ADDENDUM NO. 1

**RE: City of Dublin
Dublin Community Recreation Center
Geothermal Project
Dublin, Ohio
PEA-13390**

Date: December 18, 2014

GEOHERMAL CONDENSER WATER PIPING SCHEMATIC - BASE BID

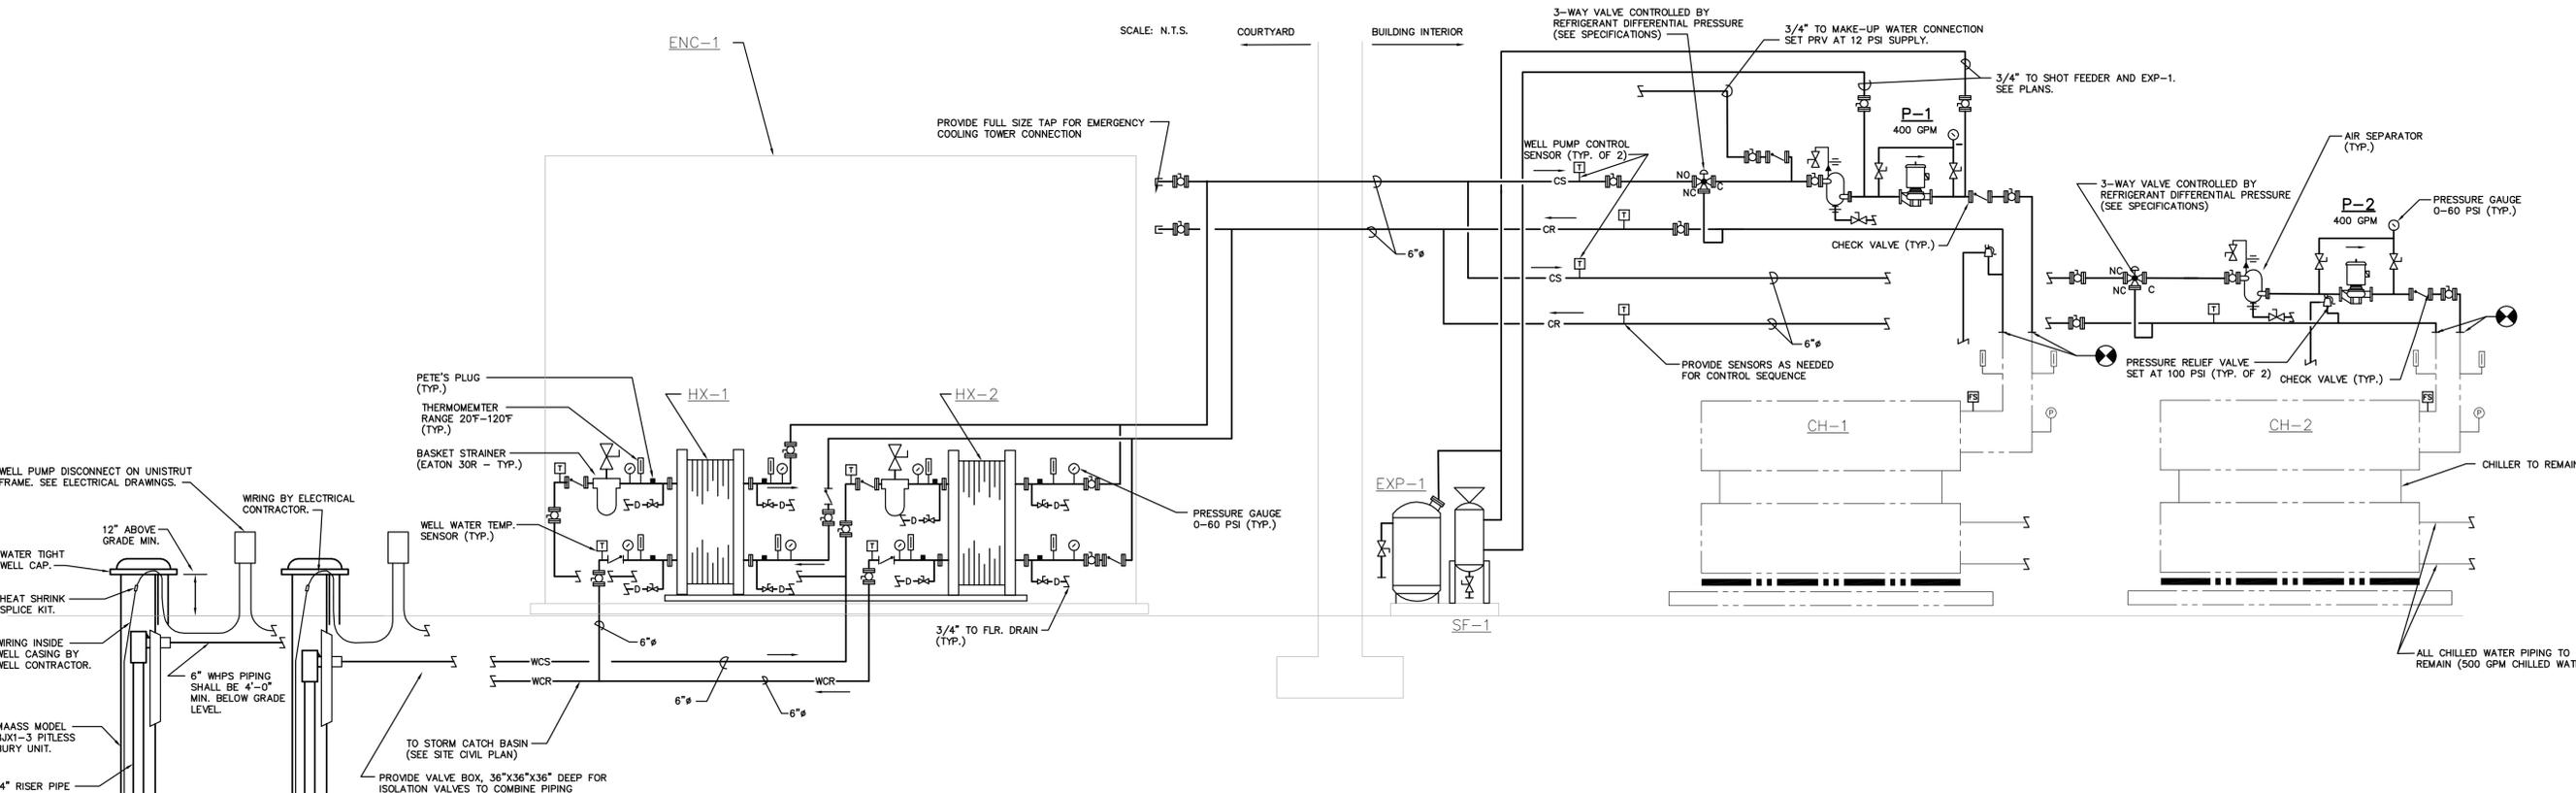
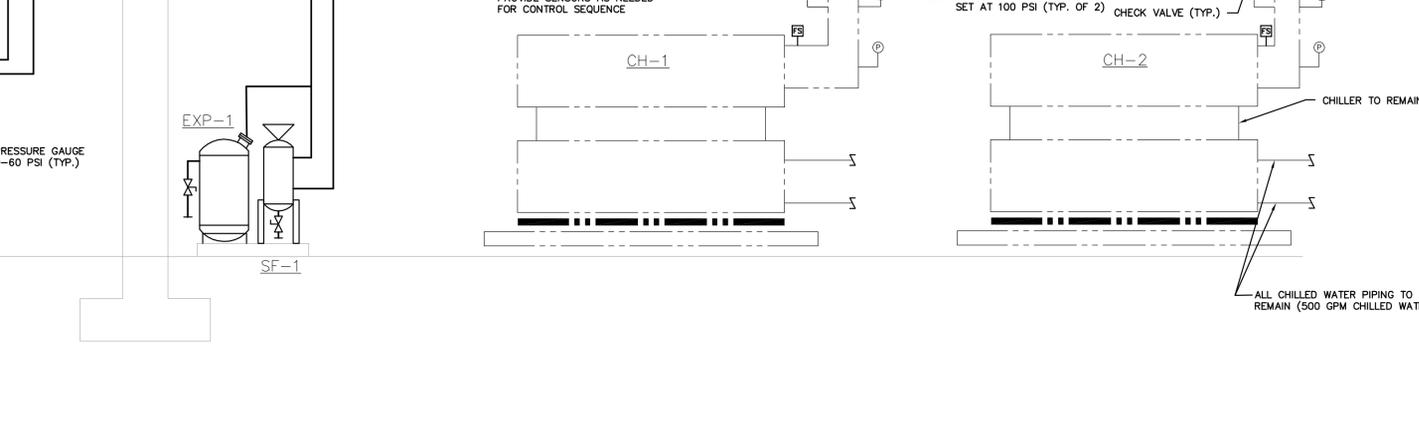
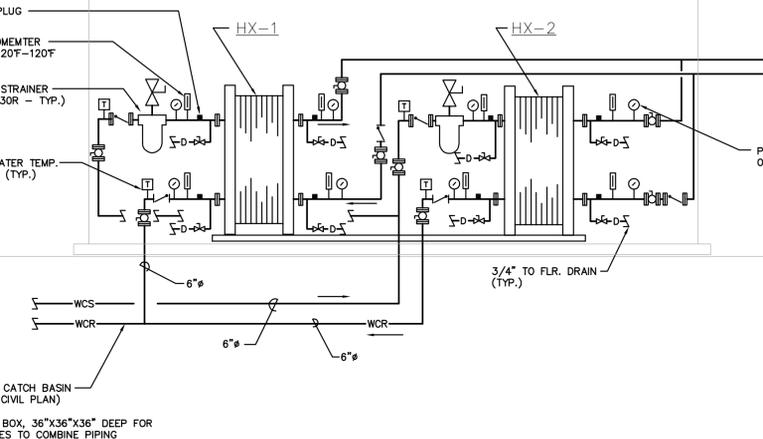
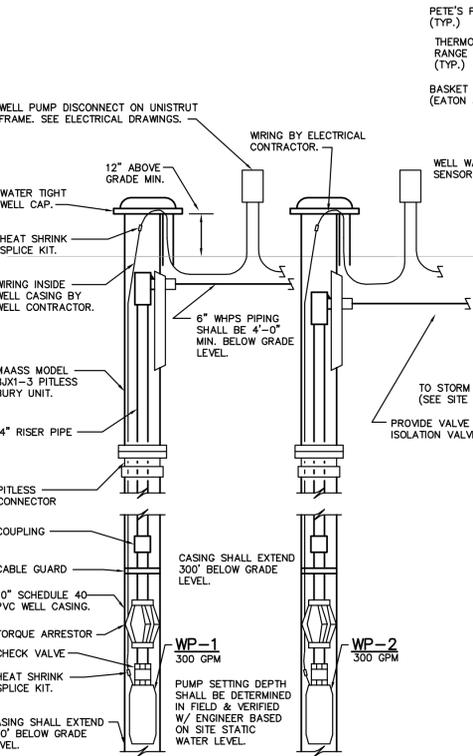
- A. Replace the bid sheet with the attached. Base bid piping diagram is included, to reduce the amount of directional bore work required and add isolation valves to the well supply from each well pump.

sheet title
**MECHANICAL
SCHEDULES**

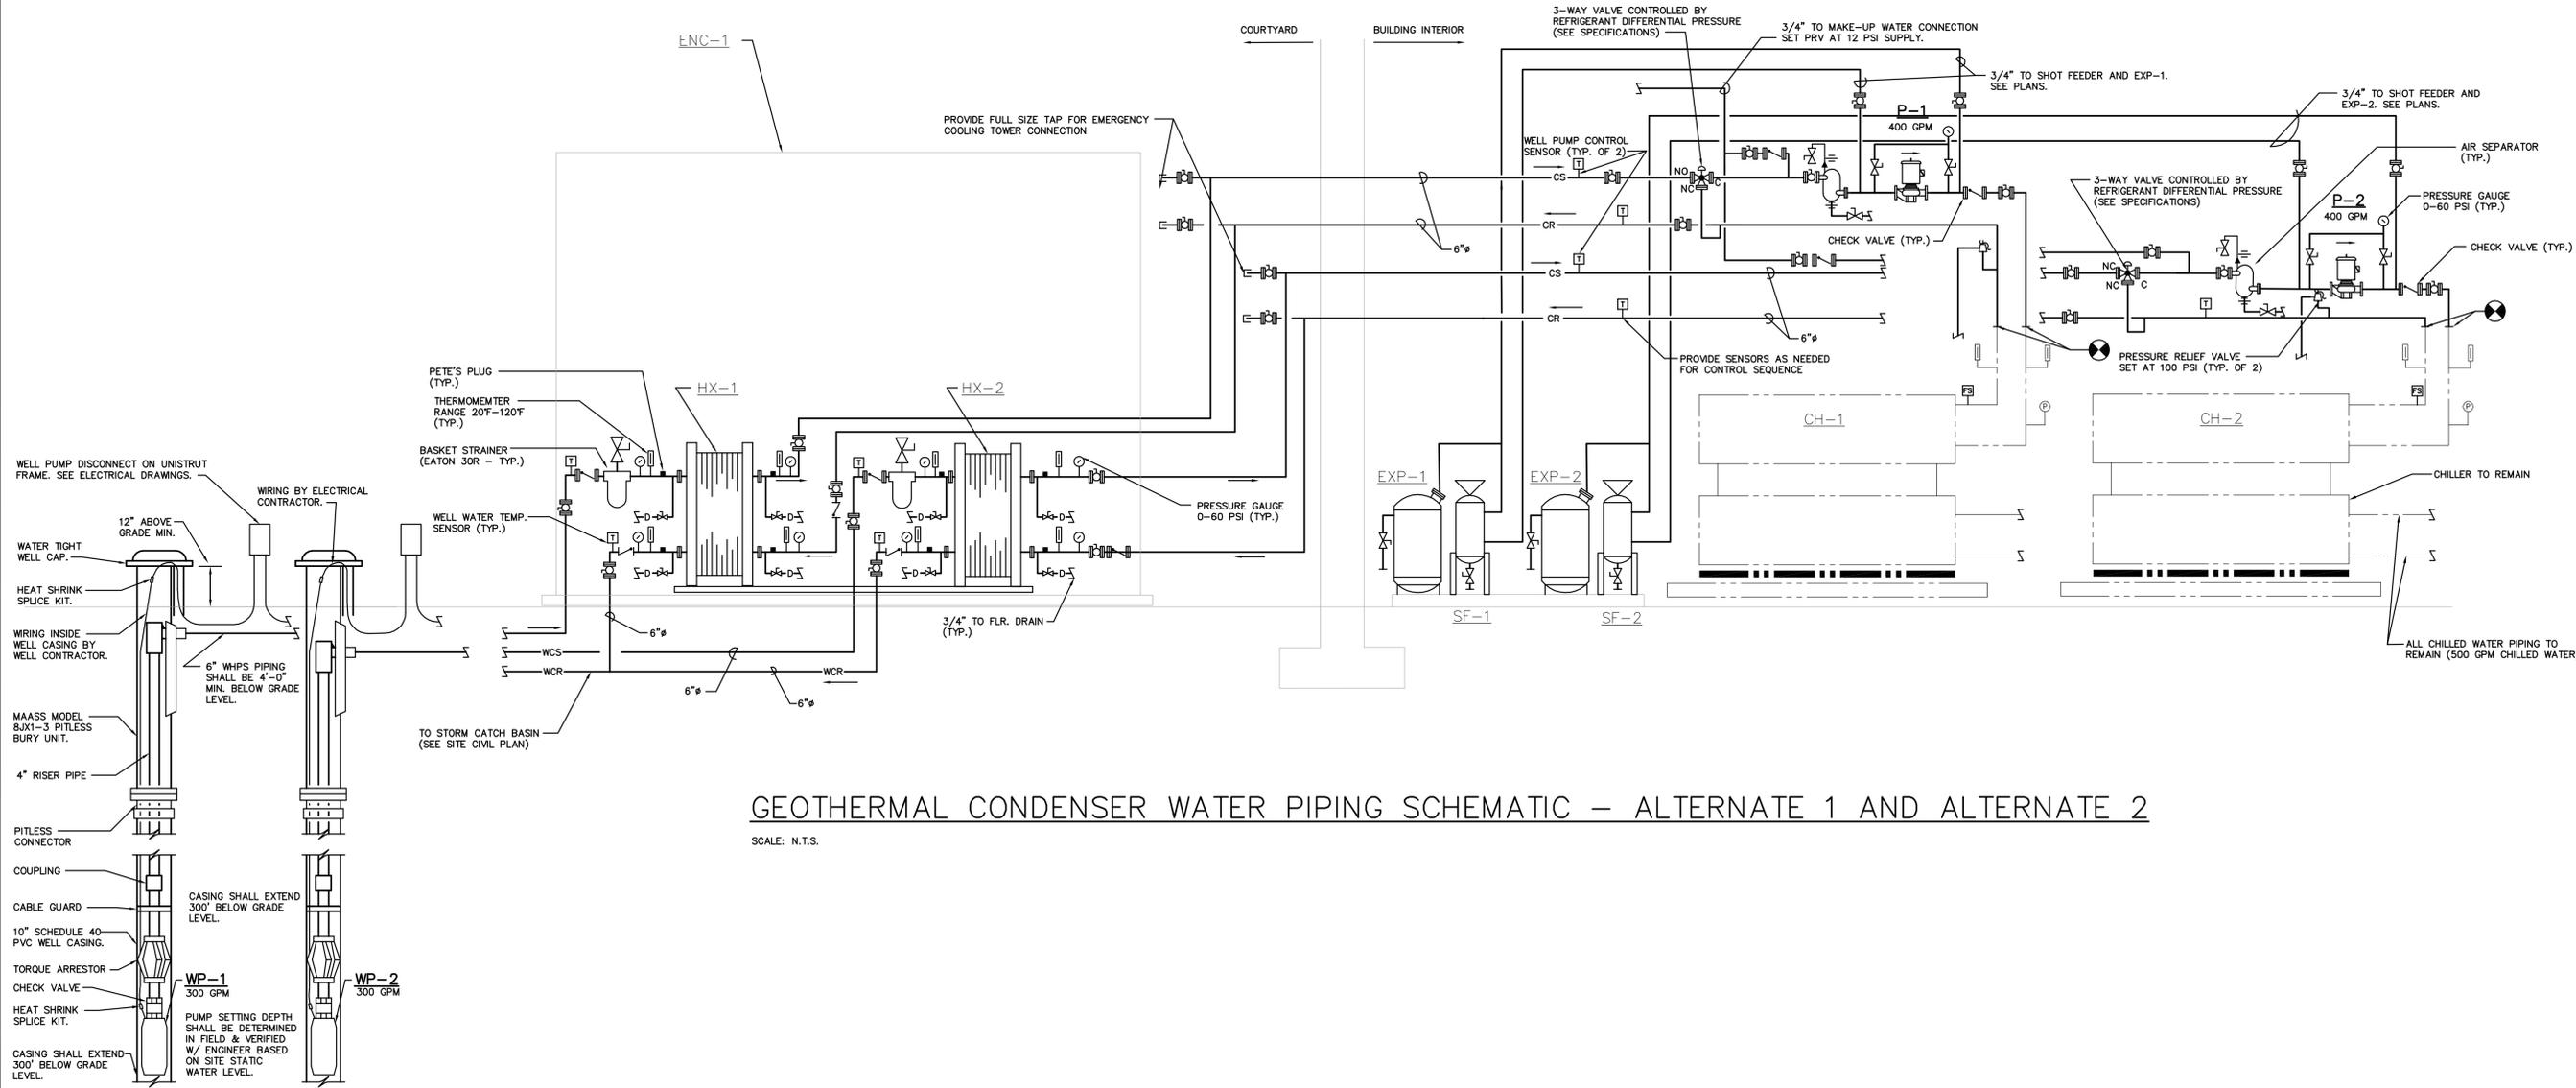
- A. Replace the bid sheet with the attached. Mechanical equipment specifications were added for EF-1, UH-1, shot feeders and expansion tanks, and alternate enclosure manufacturers were added.

- ENC-1**
EQUIPMENT ENCLOSURE - TUFF SHED "INDUSTRIAL PRO" EXTERIOR STORAGE SHED, OR EQUAL BY ARMSTRONG OR T.M. PROVIDE CUSTOM ENCLOSURE, BUILD AROUND THE HEAT EXCHANGERS AND PIPING, NOMINAL 10 FT. x 13 FT. x 9 FT. HIGH ENCLOSURE SHALL BE COMPLETE WITH GALVANIZED STEEL INSULATED FLOOR, INSULATED WALLS (R-13) WITH INTERIOR WEATHER PROOF FINISH, WOOD FRAMED WALLS 16" ON CENTER, 7/16" ROOF DECK WITH 2x4 RAFTERS AT 24" ON CENTER, 6" EAVE, 5/12 PITCHED ROOF, 96" CLEAR INSIDE HEIGHT, ENTRY DOOR SHALL BE 6 FT WIDE DOUBLE DOORS TO ALLOW MAINTENANCE ACCESS TO ALL INSIDE EQUIPMENT, 5 YEAR WARRANTY ON ALL MATERIALS, 50 YEAR WARRANTY ON SIDING AND TRIM, AND LIFETIME WARRANTY ON SHINGLES. UNIT SHALL BE DESIGNED FOR 40 LBS OF SNOW LOAD AND 90 MPH WINDS, WITH DESIGN SEALED BY AN OHIO-REGISTERED PROFESSIONAL ENGINEER. UNIT SHALL ANCHOR TO THE EXISTING CONCRETE, OR SHALL BE PROVIDED WITH PIER FOUNDATIONS. LOCATION OF FOUNDATIONS SHALL BE COORDINATED WITH ALL UNDERGROUND UTILITIES, HEAT, LIGHTS, AND POWER SHALL BE PROVIDED BY ON-SITE CONTRACTORS AS PART OF THIS PROJECT. REFER TO THE ELECTRICAL DRAWINGS FOR LIGHT FIXTURE AND POWER INFORMATION.

- UH-1**
UNIT HEATER OMARK MODEL "MUH", 5.0KW, 277V, 1PH, 18.0 AMPS, WITH UNIT MOUNTED THERMOSTAT.
- EF-1**
EXHAUST FAN GREENHECK MODEL NO. "SP-A510", 325 CFM AT 0.5" ESP, 4.0 SONES, 1070 RPM, 120V, 1PH, 3.3 AMPS, 324 WATTS, PROVIDE WITH WC-18x8 HOODED WALL CAP AND THERMOSTAT WITH ON/OFF/AUTO SUB-BASE.
